Product / Process Change Notification (PCN)

PCN Number: PCN_IndLHCA_20250228 Affected Series: WE-LHCA Affected Order Codes: Please refer to table 1 PCN Date: 2024-08-28 (YYYY-MM-DD) Effective Date: 2025-02-28 (YYYY-MM-DD)		Change Category: ☐ Equipment/Location ☐ General Data ☐ Material ☐ Process ☐ Product Design ☒ Shipping/Packaging ☐ Supplier ☐ Software																														
Contact: Product Management Phone: +49 (0) 7942 - 945 5001 Fax: +49 (0) 7942 - 945 5179 E-Mail: pcn.eisos@we-online.com		Datasheet Change: ☒ Yes ☐ No Attachment: ☐ Yes ☒ No																														
Description of Change: Due to packaging optimizations, Würth Elektronik eiSos will change the product's packing method. Würth Elektronik eiSos will ensure some datasheet corrections for the product series WE-LHCA with sizes and order codes indicated in table 1. There will be no change in form, fit, function, quality, or reliability of the product. The new revision of the affected order codes will be sent out after the previous revision is out of stock (according to FIFO - first-in, first-out).																																
Details of Change: Table 1. Affected Order Codes

Table 2. Packaging Changes of affected Order Codes

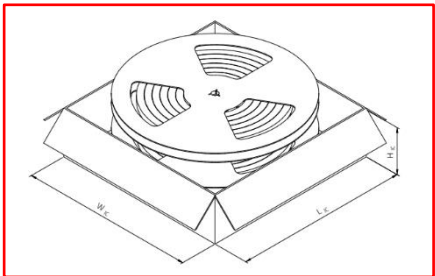
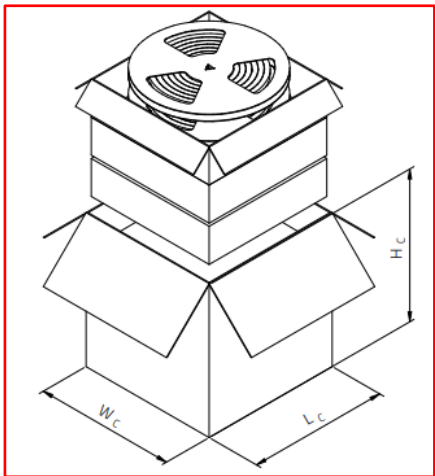
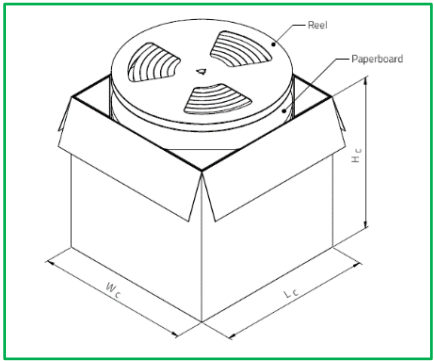
1. To reduce the amount of packaging waste in the product series WE-LHCA, with sizes and order codes indicated in table 1, the inner boxes will be omitted. No plastic filler will be used, and every reel will be stacked and separated by paperboard. The outer box dimension, reel quantity (pcs.), and box quantity (pcs.) will be updated accordingly. Additional details of the changes can be found in the table below:

Overview of inner packing change																		
Packaging specifications for size 7030 (Table 1 section a)	<table><tr><td>L_c(mm)</td><td>360,00</td></tr><tr><td>W_c(mm)</td><td>360,00</td></tr><tr><td>H_c(mm)</td><td>370,00</td></tr><tr><td>Outer Box Qty.(pcs.)</td><td>9000</td></tr></table>	L _c (mm)	360,00	W _c (mm)	360,00	H _c (mm)	370,00	Outer Box Qty.(pcs.)	9000	<table><tr><td>L_c(mm)</td><td>360,00</td></tr><tr><td>W_c(mm)</td><td>360,00</td></tr><tr><td>H_c(mm)</td><td>240,00</td></tr><tr><td>Outer Box Qty.(pcs.)</td><td>9000</td></tr></table>	L _c (mm)	360,00	W _c (mm)	360,00	H _c (mm)	240,00	Outer Box Qty.(pcs.)	9000
L _c (mm)	360,00																	
W _c (mm)	360,00																	
H _c (mm)	370,00																	
Outer Box Qty.(pcs.)	9000																	
L _c (mm)	360,00																	
W _c (mm)	360,00																	
H _c (mm)	240,00																	
Outer Box Qty.(pcs.)	9000

Packaging specifications for size 1040 (Table 1 section b)	<table><tr><td>L_c(mm)</td><td>360,00</td></tr><tr><td>W_c(mm)</td><td>360,00</td></tr><tr><td>H_c(mm)</td><td>370,00</td></tr><tr><td>Outer Box Qty.(pcs.)</td><td>4800</td></tr></table>	L _c (mm)	360,00	W _c (mm)	360,00	H _c (mm)	370,00	Outer Box Qty.(pcs.)	4800	<table><tr><td>L_c(mm)</td><td>360,00</td></tr><tr><td>W_c(mm)</td><td>360,00</td></tr><tr><td>H_c(mm)</td><td>240,00</td></tr><tr><td>Outer Box Qty.(pcs.)</td><td>4800</td></tr></table>	L _c (mm)	360,00	W _c (mm)	360,00	H _c (mm)	240,00	Outer Box Qty.(pcs.)	4800
L _c (mm)	360,00																	
W _c (mm)	360,00																	
H _c (mm)	370,00																	
Outer Box Qty.(pcs.)	4800																	
L _c (mm)	360,00																	
W _c (mm)	360,00																	
H _c (mm)	240,00																	
Outer Box Qty.(pcs.)	4800																	
Packaging specifications for size 1365 (Table 1 section c)	<table><tr><td>L_c(mm)</td><td>360,00</td></tr><tr><td>W_c(mm)</td><td>360,00</td></tr><tr><td>H_c(mm)</td><td>370,00</td></tr><tr><td>Outer Box Qty.(pcs.)</td><td>2400</td></tr></table>	L _c (mm)	360,00	W _c (mm)	360,00	H _c (mm)	370,00	Outer Box Qty.(pcs.)	2400	<table><tr><td>L_c(mm)</td><td>360,00</td></tr><tr><td>W_c(mm)</td><td>360,00</td></tr><tr><td>H_c(mm)</td><td>240,00</td></tr><tr><td>Outer Box Qty.(pcs.)</td><td>2400</td></tr></table>	L _c (mm)	360,00	W _c (mm)	360,00	H _c (mm)	240,00	Outer Box Qty.(pcs.)	2400
